WELL API NO. 30-025-23252
5. Indicate Type of Lease STATE <input type="checkbox"/> FEE <input type="checkbox"/>
6. State Oil & Gas Lease No.
7. Lease Name or Unit Agreement Name State I-29
8. Well Number #6
9. OGRID Number 113315
10. Pool name or Wildcat Hobbs, Upper Blinbry

SUNDRY NOTICES AND REPORTS ON WELLS
(DO NOT USE THIS FORM FOR PROPOSALS TO DRILL OR TO DEEPEN OR PLUG BACK TO A DIFFERENT RESERVOIR. USE "APPLICATION FOR PERMIT" (FORM C-101) FOR SUCH PROPOSALS.)

2. Name of Operator
Texland Petroleum-Hobbs, LLC

State 1-29 #6**Current Wellbore Schematic**

State 1-29 #6**Proposed Wellbore Schematic**

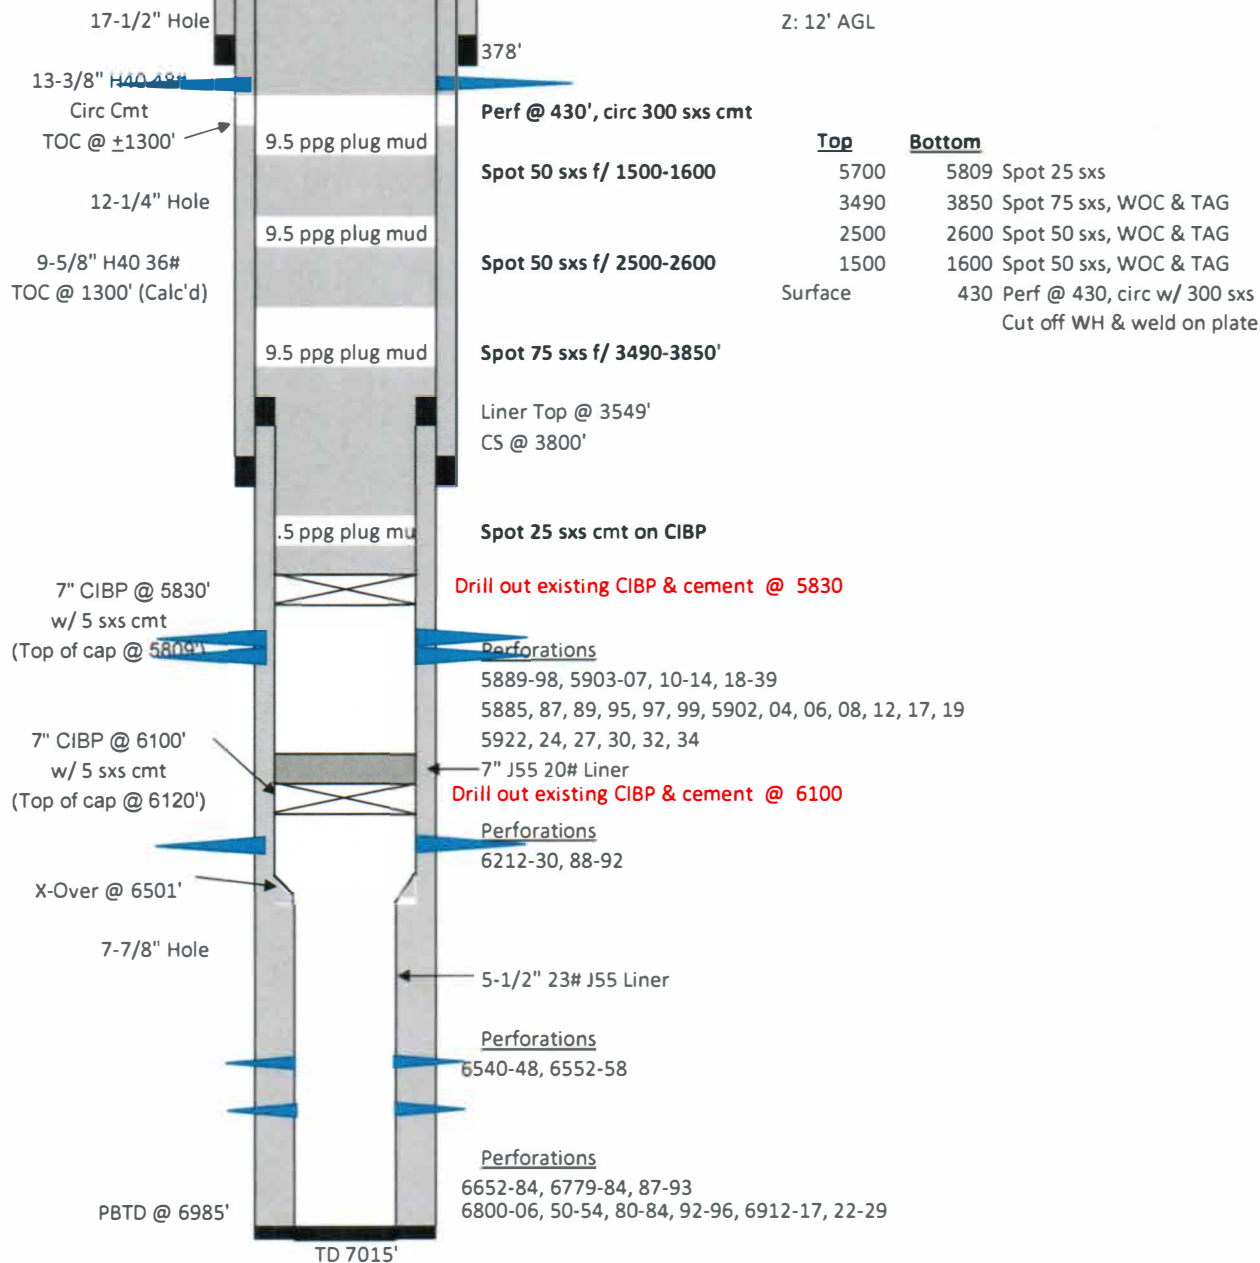
Drill out existing CIBP & cement @ 5830 and 6100 set CIBP 6440 Spot 25 sx Class C cement WOC & tag Set CIBP 6112 Spot 25 sx Class C WOC & tag

Set CIBP 5800 Spot 25 Sx Class C cement WOC & tag Pressure test casing Circ MLF

4" diameter 4' tall Above Ground Marker

Operator: TEXLAND PETROLEUM-HOBBS, LLC			777 Main Street	Fort Worth, TX76102	OGRID: 113315	Action Number: 28329	Action Type: C-103F
OCD Reviewer		Condition					
kfortner		See Attached conditions of approval Note changes to procedure
